Form 3160-5
(March 2012)

SUNDRY NOTICES AND REPORTS ON WELLS
Do not use this form for proposals to drill or to re-enter an abandoned well. Use Form 3160-3 (APD) for such proposals.

8. Well Name and No.
MARATHON MARTINEZ FEDERAL #1

Marathon Martinez #1 plugging procedure dated 11/21/14 for BLM Form 3160-~~3~~ 5 Sundry Notice:

☑ Suggested Completion

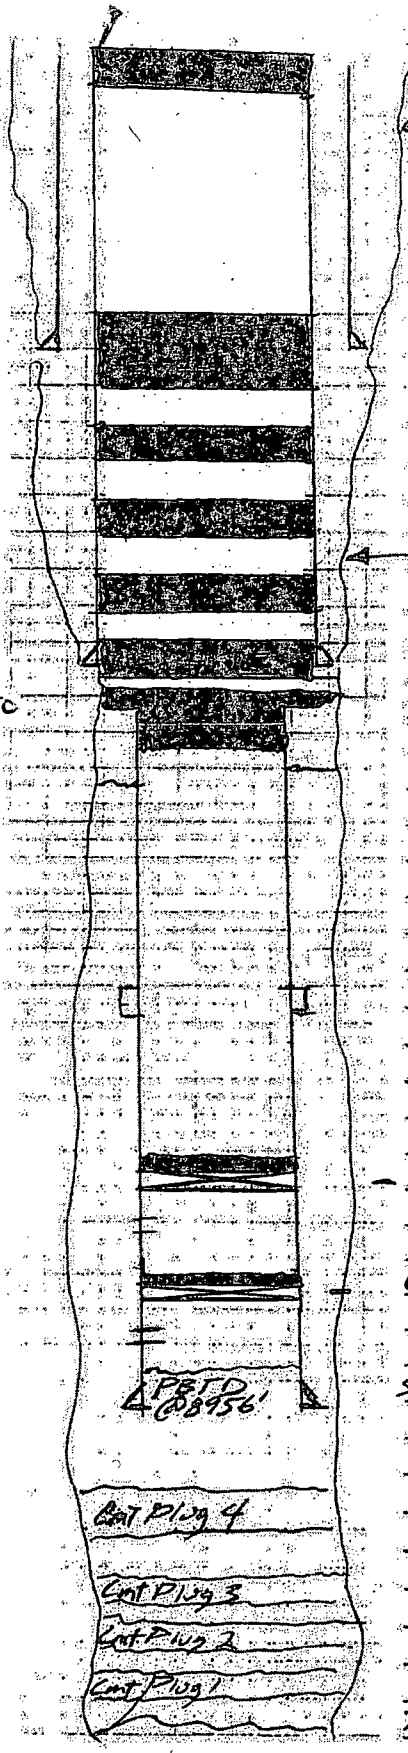
MIRU well service rig and MIRU Electricline Unit and mast. 35' Dump Bail. Add: Spot plug (160') from 5879-5719 WOC Tag.
Set CIBP @ 8810'. Dump bail 3 sxs cmt on CIBP. Set CIBP @ 4610' and dump bail 3 sxs cmt on CIBP. RD ELU. Deliver to location workstring tubing. ND wellhead. NU BOP. TIH w/ tbg to 4600' and circ well with 9.5 ppg Brine w/ 12.5#salt gel/BBL using closed loop system.
Cut and pull 5 1/2" csg @ 3500' (Use stretch calc to find free csg).
TOH w/ tbg to 3550' (50' below 5 ½" csg stub). Spot ~~100'~~ Class C cmt plug ~~3450'~~ 3420' to 3550' (Tag plug after WOC). 130' plug
TOH w/ tbg to 3201' (50' below 9 5/8" csg shoe). Spot ~~100'~~ Class C cmt plug ~~3101'~~ to 3201' (Tag plug after WOC). 2?4' plug (shoe & Top Del.
TOH w/ tbg to 2530' (Top of San Andres). Spot 100' Class C cmt plug ~~2430'~~ to 2530' (Tag plug after WOC). 120' plug (2410)
TOH w/ tbg to 1722' (Top of Queen). Spot 100' Class C cmt plug 1622' to 1722' (Tag plug after WOC).
